AGENDA OF THE PLANNING  
COMMISSION  
CITY OF BIRCHWOOD VILLAGE  
WASHINGTON COUNTY, MINNESOTA  
June 27th, 2024  
7:00 P.M.

Re: 425 Lake Avenue Variance Application – Additional Information

24-01-VB (425 Lake)

# CERTIFICATE OF SURVEY

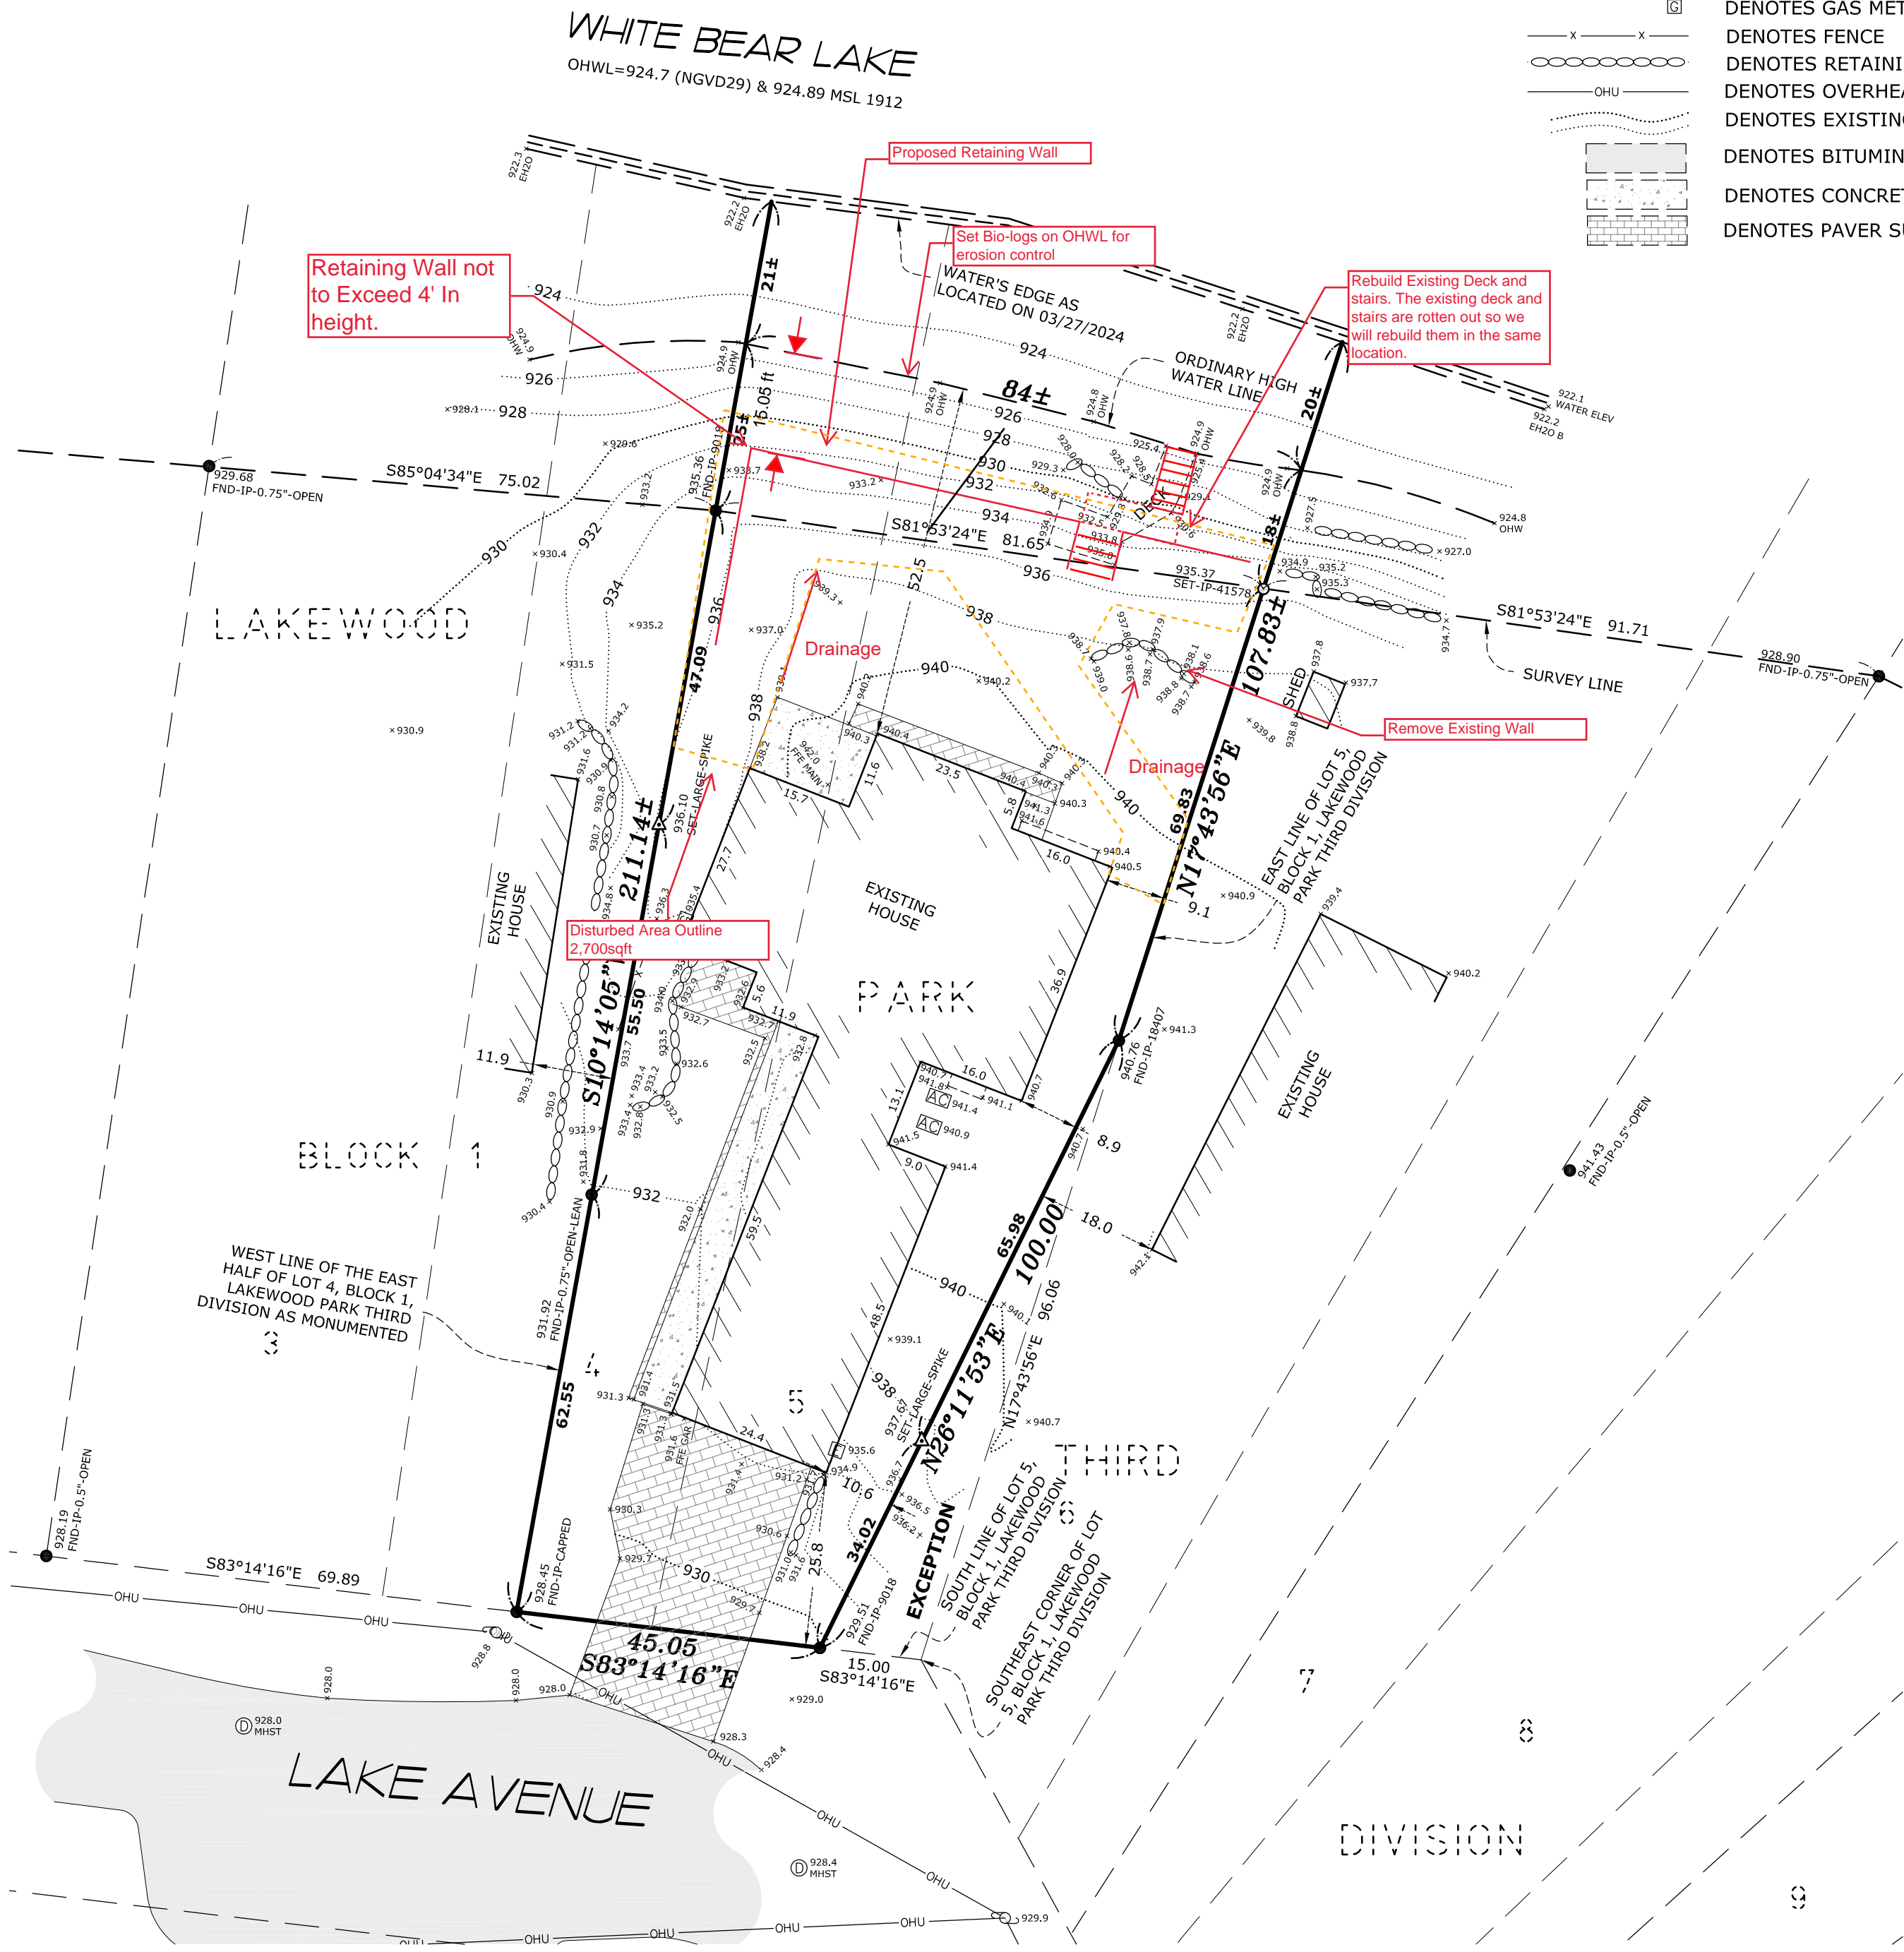
One item of note is the impervious surface. The survey shows a total impervious percentage on site of 40.2%, while the chart on the application shows 31.69%. It appears that the existing pavers and concrete elsewhere on site were left off the chart. The 33 s.f. of additional retaining wall is assumed to be correct for one tier of wall. That is staff's understanding of the proposed wall design based on correspondence from the applicant, and seems to make sense with a 50-foot wide lot. If that is the case, the proposed impervious percentage on the chart is calculated incorrectly (it adds 103 s.f. to the existing total, rather than just the new 33 s.f.). The applicant should be present to clarify. Regardless, the amount of impervious to be added is negligible, and necessary for the mitigation. 33 s.f. of additional surface would be 0.2%; 103 s.f. of additional surface would be 0.81%.

# CERTIFICATE OF SURVEY

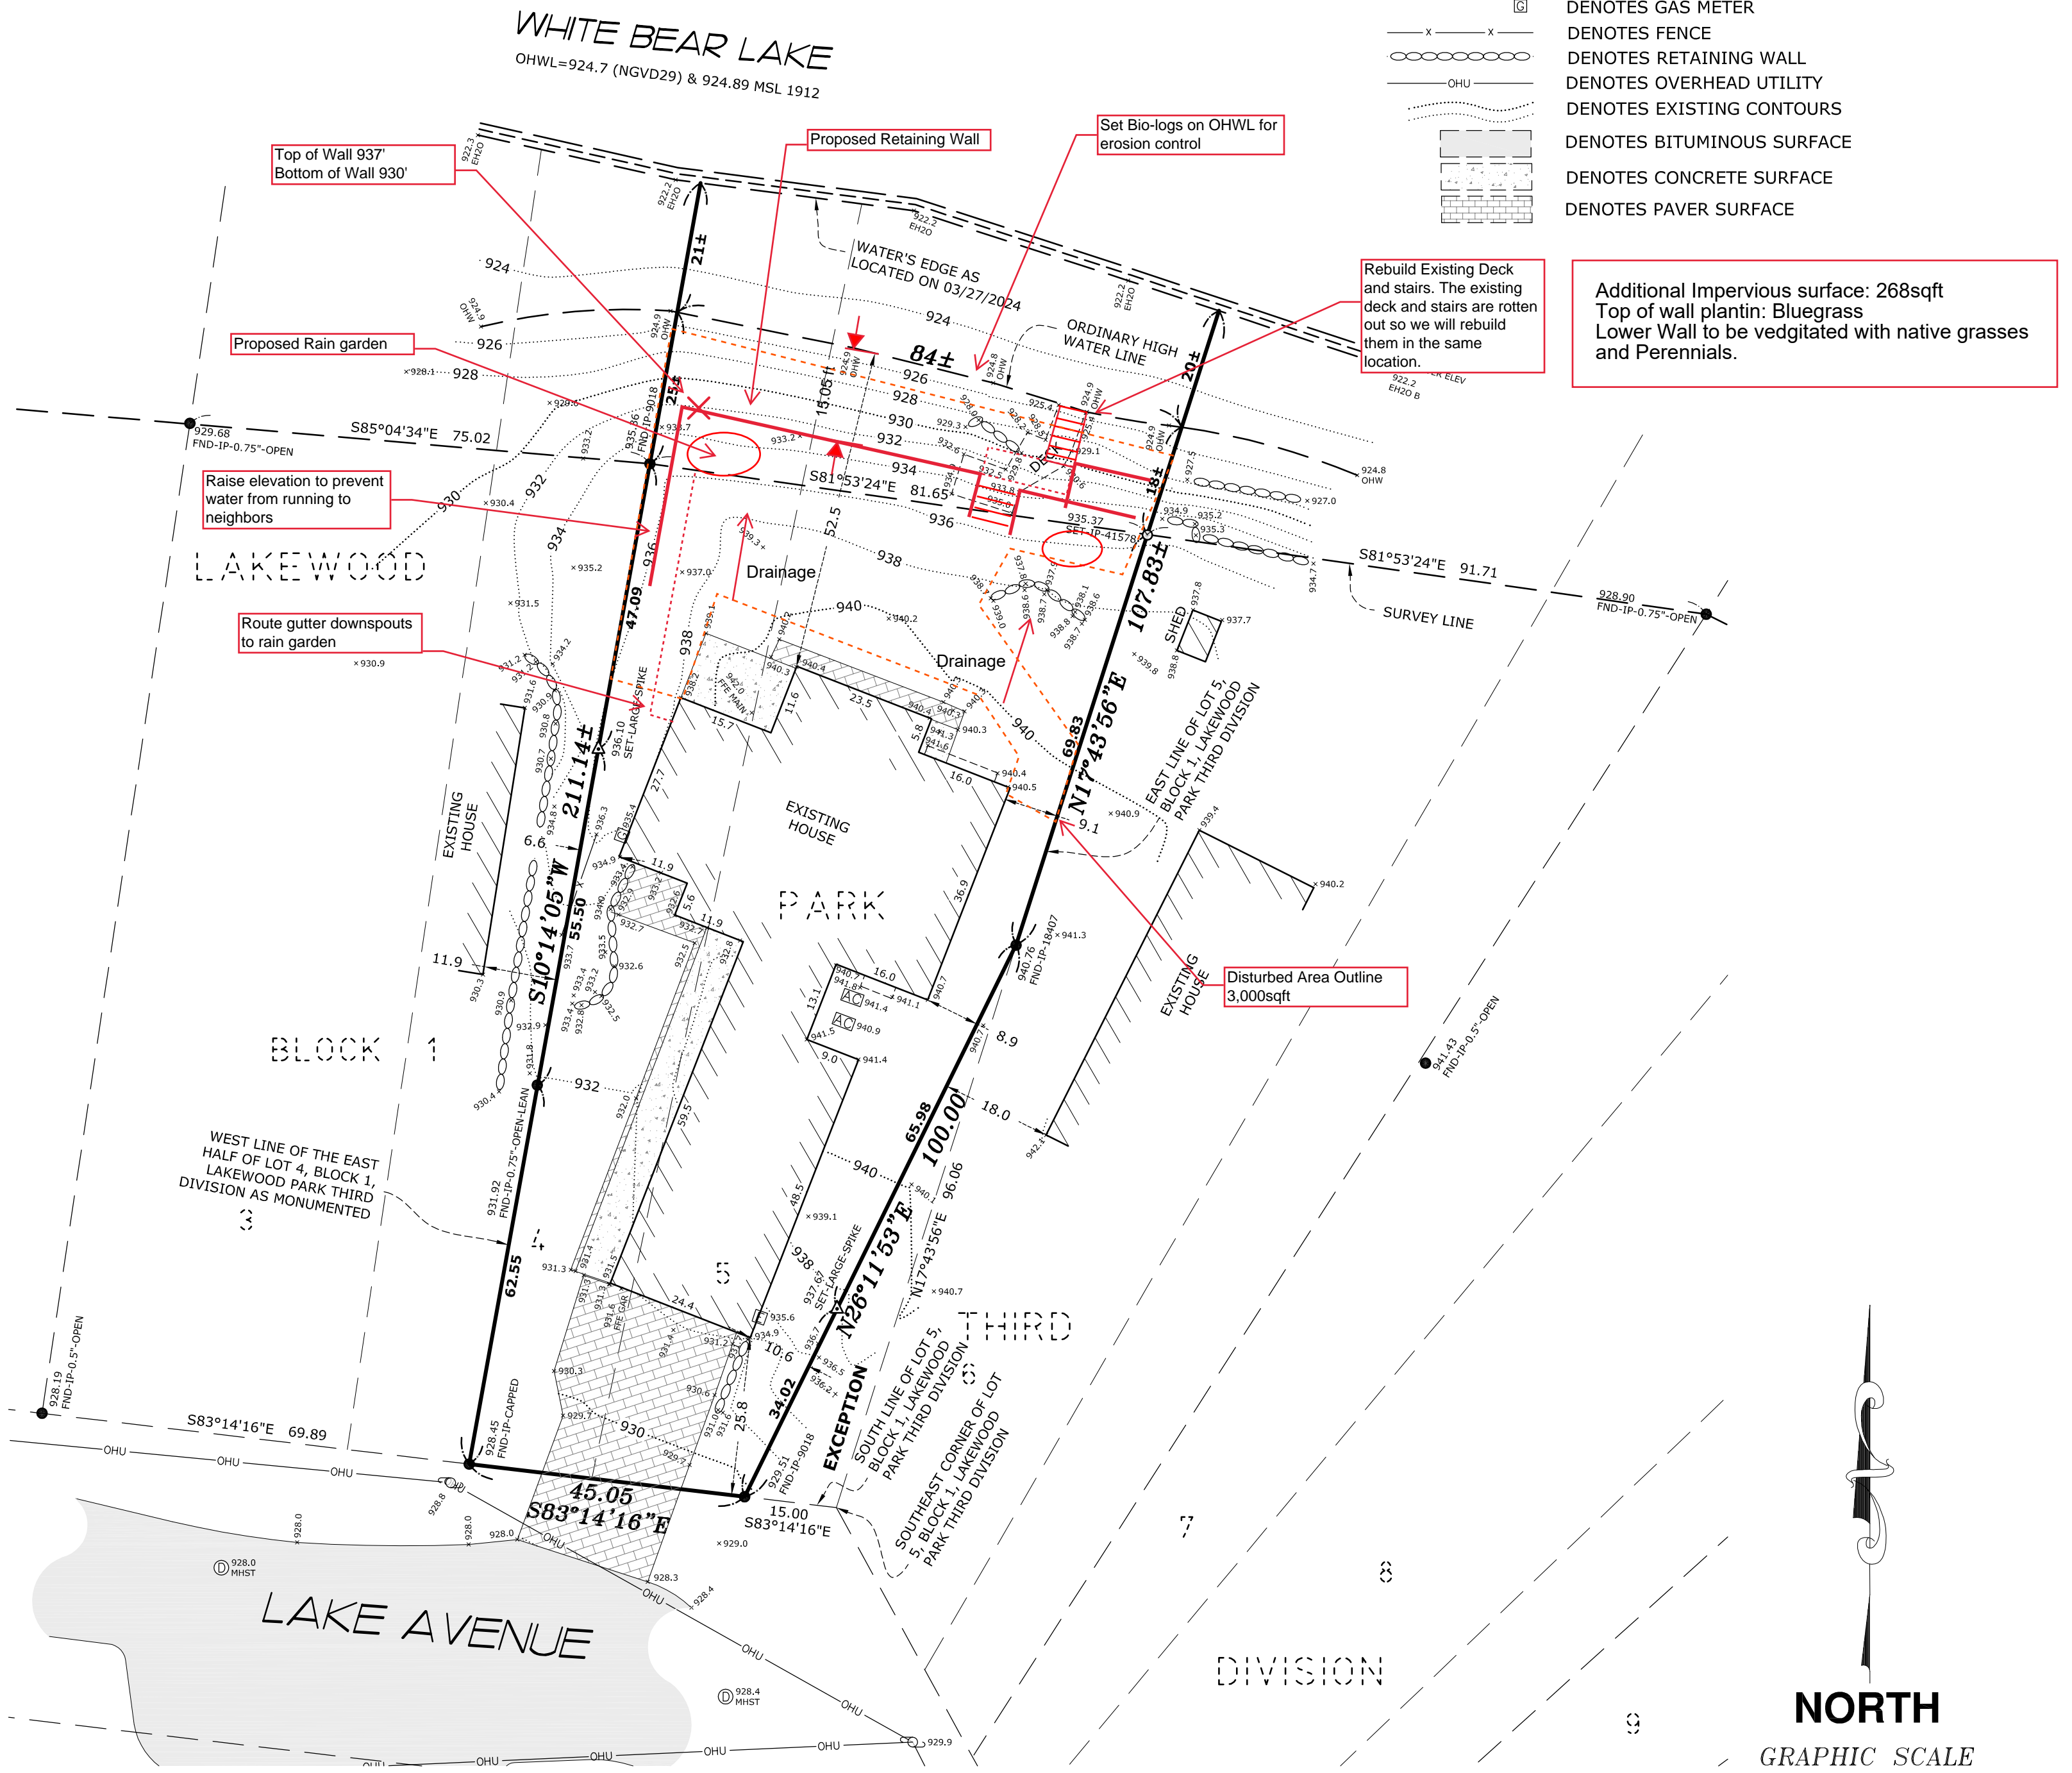
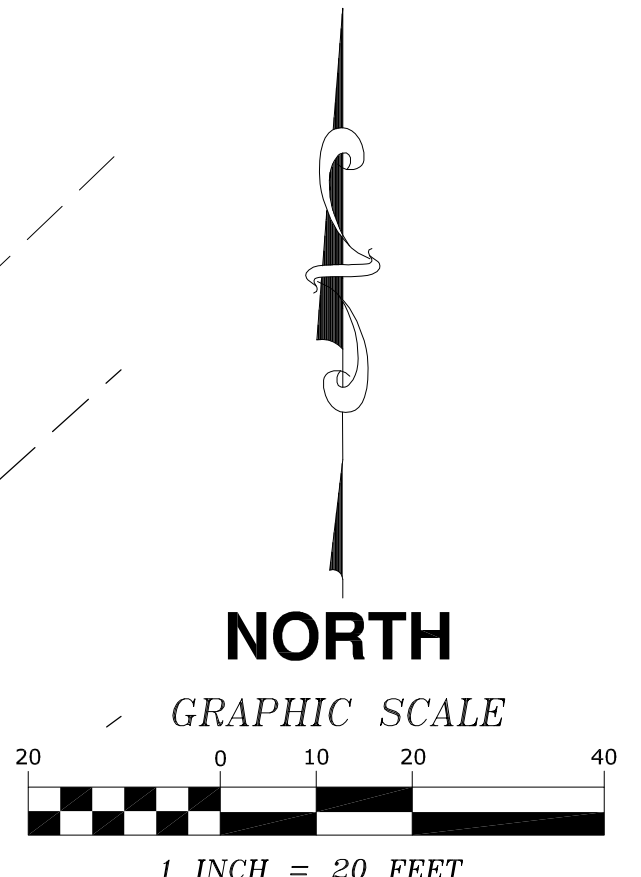
Additional Impervious surface: 268sqft  
 Top of wall plantin: Bluegrass  
 Lower Wall to be vedgitated with native grasses and Perennials.
